Yasin Knittex Ind. Ltd. (Extended Building)

23 January 2024

1. Building Information

Roof truss and column connection

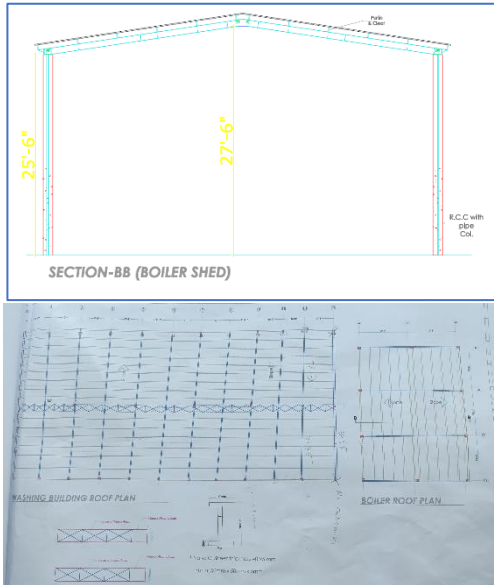
Observation-2: Lack of lateral stability and connection adequacy. (Batch Shed)

Description: Lack of lateral stability system (strut and bracing), apparent inadequate members and non-engineered connection was observed. The building engineer is required to check the member, connection & stability system of the structure and suggest proper alternatives accordingly.

Roof layout and section

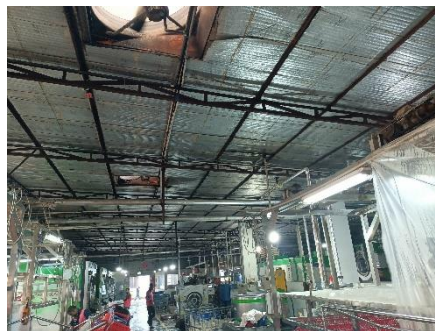
Observation-3: Lack of information and mismatches in as-built drawings. (Washing and Boiler Shed)

Description: Structural sectional details and connection details were not found in the provided as-built drawings. Also, column and truss layout not fully matched. Rafter sizes (boiler) were not mentioned.
